<b>City of Parramatta</b>	
File No:	DA/460/2021

**SECTION 4.15 ASSESSMENT REPORT**  
**Environmental Planning & Assessment Act 1979**

<b>DA No:</b>	DA/725/2020
<b>Subject Property:</b>	LOT 14 DP 30791, 45 Mobbs Lane, CARLINGFORD NSW 2118
<b>Proposal:</b>	Section 8.3 Review of DA/725/2020 for the demolition of existing structures, earthworks, removal of seven (7) trees and construction of a child care facility for 56 children (17 x 0-2 year olds, 15 x 2-3 year olds & 24 x 3-6 year olds) with basement level car parking level for fourteen (14) vehicles and associated landscape works. The Section 8.3 Review of Determination application relies upon previously submitted amended plans for 56 children with 14 car parking spaces.
<b>Date of receipt:</b>	7 December 2020 (Section 8.3 Review lodged on 5 April 2022)
<b>Applicant:</b>	Planning Lab
<b>Owner:</b>	Child Care Property Holdings Pty Limited
<b>Property owned by a Council employee or Councillor:</b>	The site is not known to be owned by a Council employee or Councillor
<b>Political donations/gifts disclosed:</b>	None disclosed on the application form

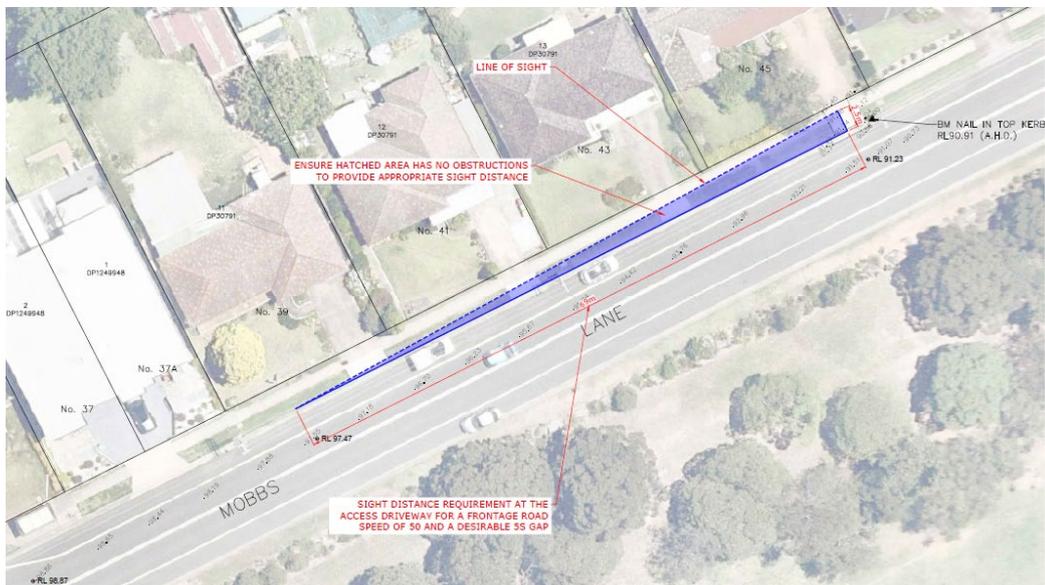
It is noted that Annexure B drawings in the submitted traffic report illustrates the sight distance required based on AS2890.1-2004 and Austroads (minimum gap sight distance and safe intersection sight distance).

These drawings demonstrate that there is insufficient sight distance provided due to the presence parked vehicles on the kerbside lane.

The proposed 'No Stopping' restriction along the site frontage is not supported as this will not provide adequate sight distance and can also set a precedence for other childcare developments within the LGA.

Note that in order to provide adequate sight distance based AS2890.1-2004, a 69m long 'No Stopping' restriction will need to be provided on Mobbs Lane, west of the driveway (see below figure), This will adversely impact parking amenities in the area which is not supported.
